SSES-FSAR

QUESTION 400.1

The Quality Assurance Branch (QAB) has reviewed Pennsylvania Power and Light Company's (PP&L) Fire Protection Report (dated January 18, 1978) for Susquehanna Steam Electric Station (SSES) Units 1 and 2. This report was submitted in response to Mr. Boyd's letter of September 30, 1976. Based on our review of this information, we find that adequate information has not been submitted by PP&L to permit completion of the QAB review of the fire protection program.

FIGURE 423.3-1, Rev 47

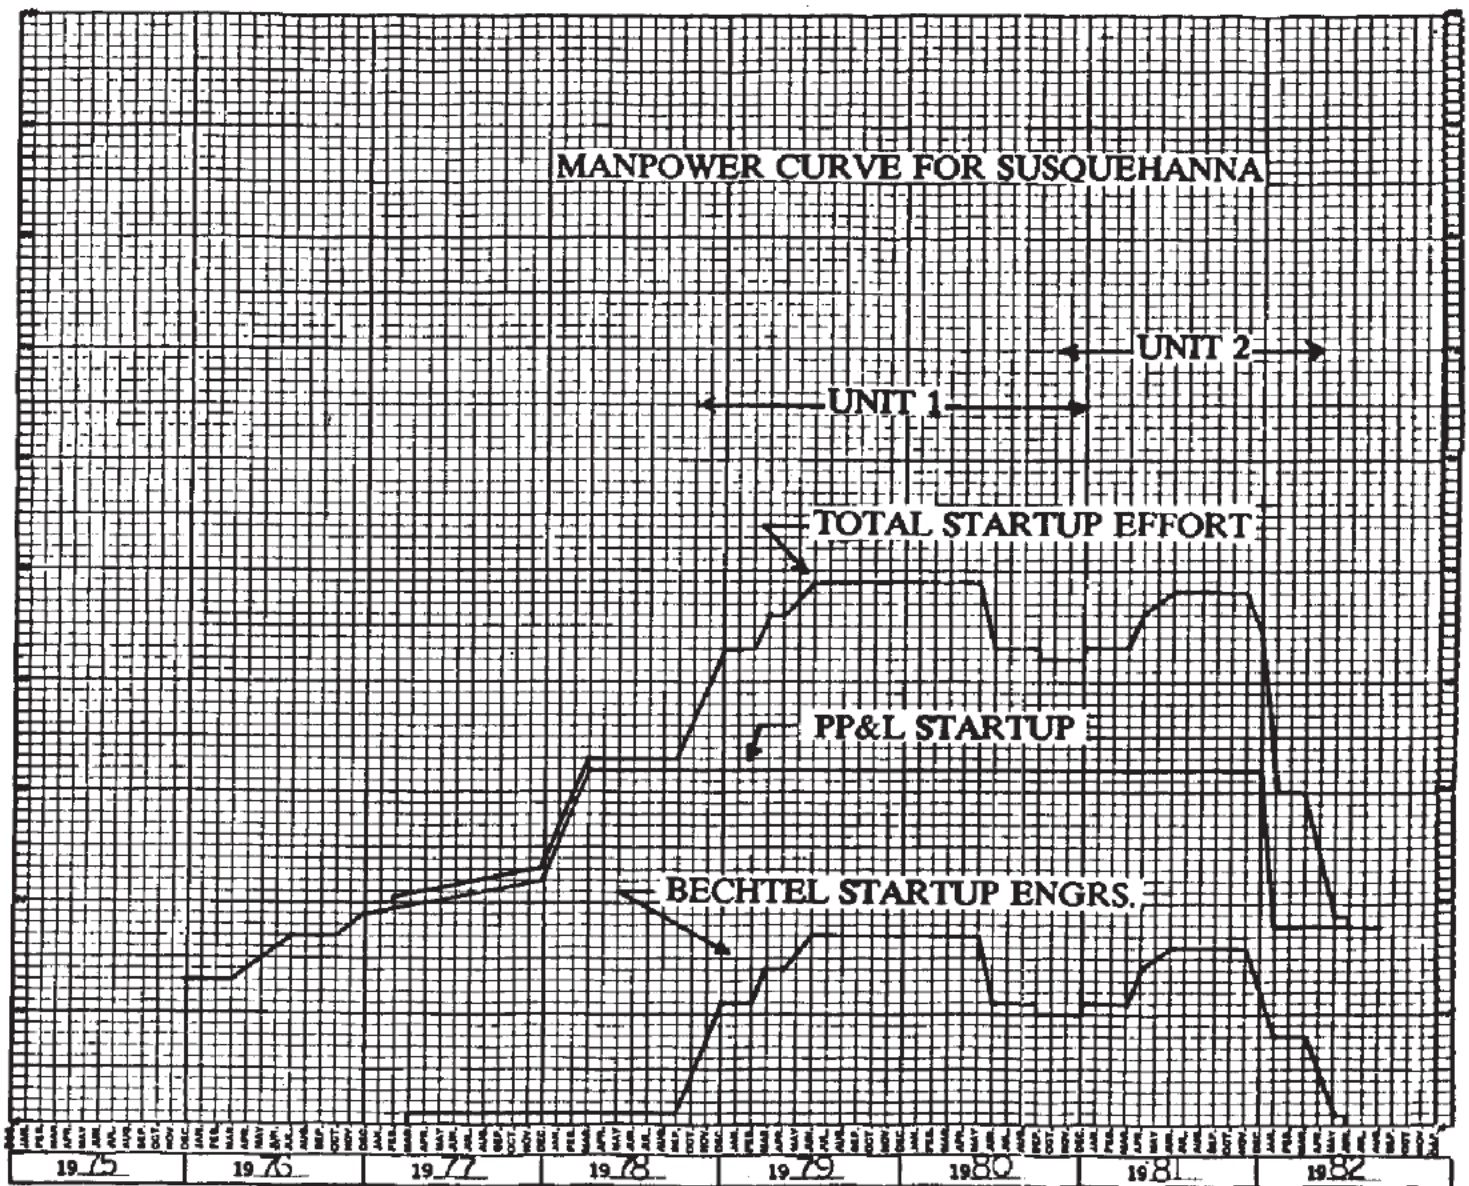
State the approximate number of test personnel that will be assigned to augment the plant staff (e.g., the integrated startup group) and the approximate schedules (relative to fuel loading) for assignment.

The Integrated Startup Group plans to have approximately forty-nine (49) engineers for the Initial Test Program in addition to the Plant Staff people. A schedule for this estimated manpower loading is attached.
